Louisiana Energy Services, L. P.
National Enrichment Facility
NRC Docket No. 70-3103

Subject: Response to NRC Request for Additional Information Regarding the National Enrichment Facility Environmental Report

**Louisiana Energy Services
Response to April 29, 2004,
Request for Additional Information**

Figure ER RAI 4-1.3

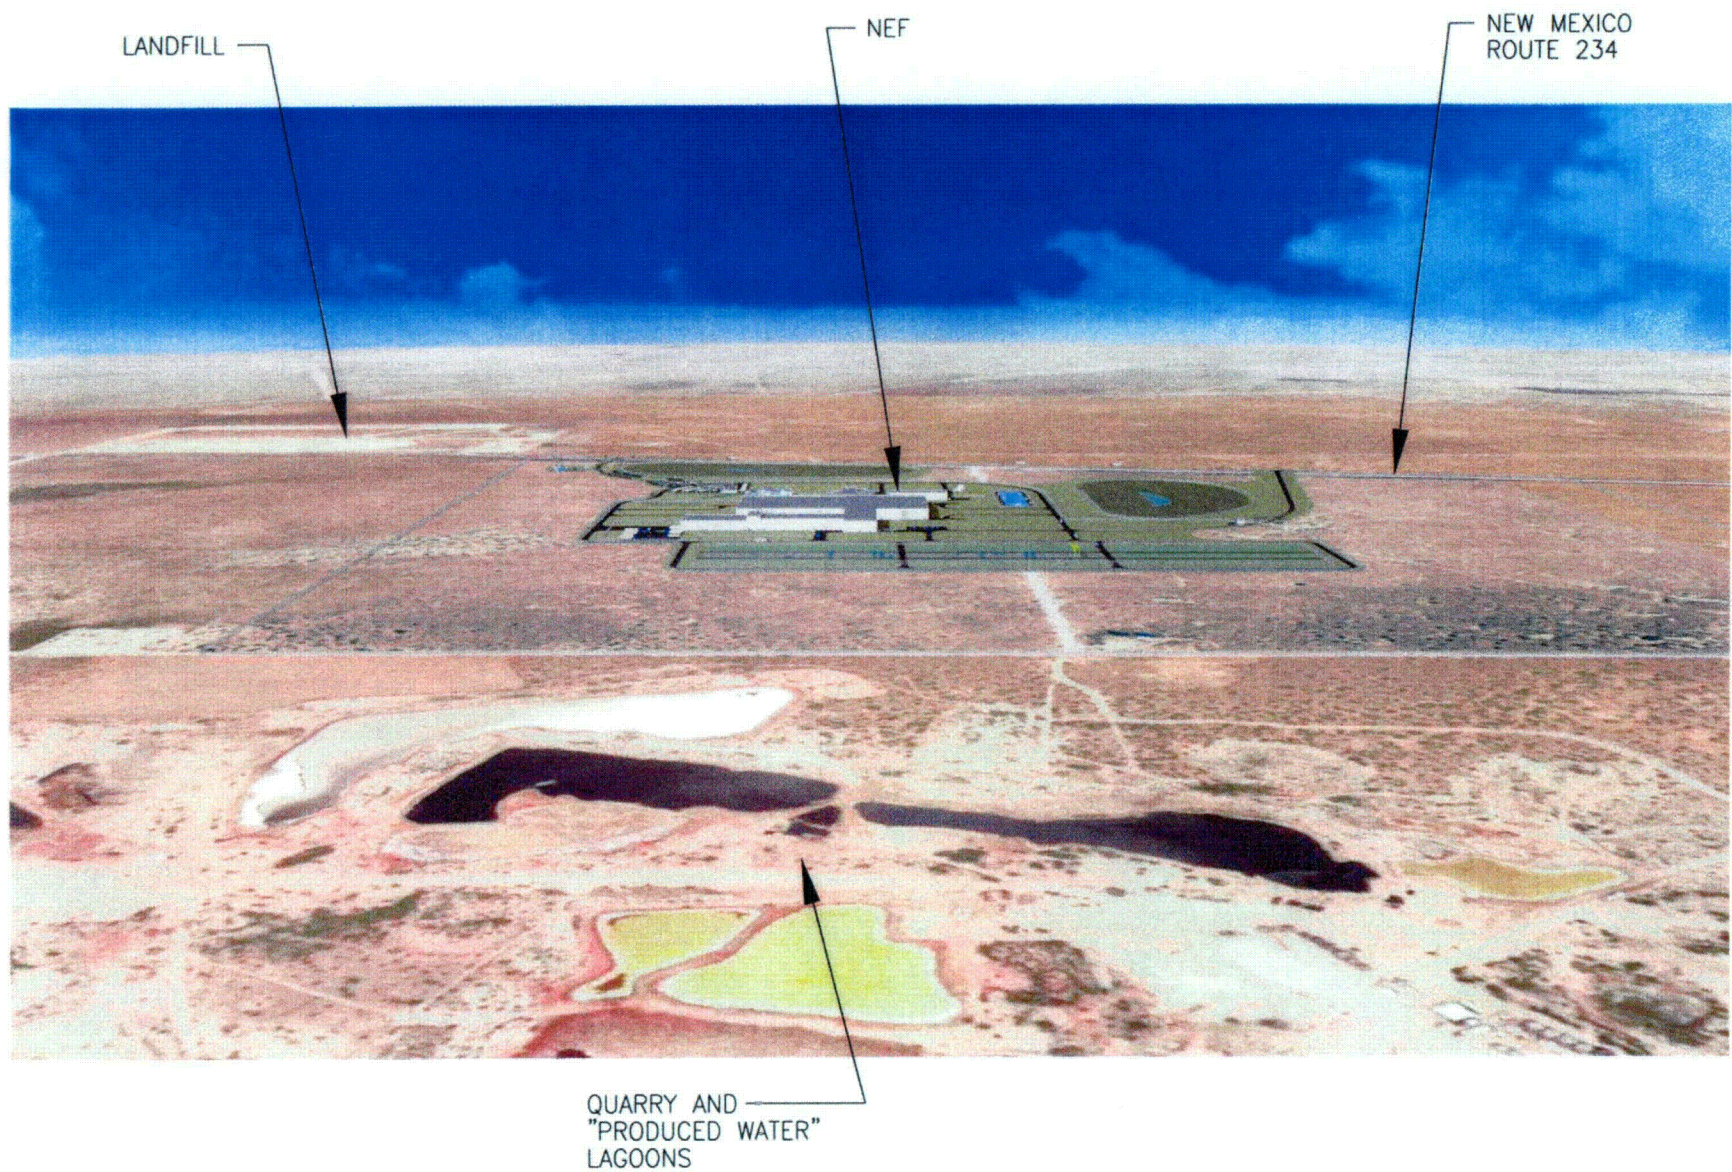
Provide a copy of the artistic rendering showing a view of the proposed NEF and how it would visually impact the site and surrounding area.

Figure ER RAI 4-1.1, "Aerial View," is an artistic aerial view of the NEF and surrounding area. Figure ER RAI 4-1.2, "View to the Northwest," Figure ER RAI 4-1.3, "View to the East," Figure ER RAI 4-1.4, "View to the South," and Figure ER RAI 4-1.5, "View to the West," in Attachment 3 to this submittal, provide artistic views of the NEF site and vicinity, looking to the northwest, east, south and west, respectively. The quarry and "produced water" lagoons to the north, the existing Waste Control Specialists (WCS) waste facility to the east, the county landfill to the southeast and New Mexico Route 234 to the south are shown in relation to the NEF site. Land to the west, occupied by a petroleum contaminated soil treatment facility, is undeveloped. Viewing the surrounding area from the NEF site, and looking northward, the quarry and "produced water" lagoons are at a higher elevation. To the east, several low-rise buildings associated with the WCS waste facility are apparent at a distance. Earthen mounds are apparent to the southeast, across New Mexico Route 234. No structures are visible on the adjacent property to the west.
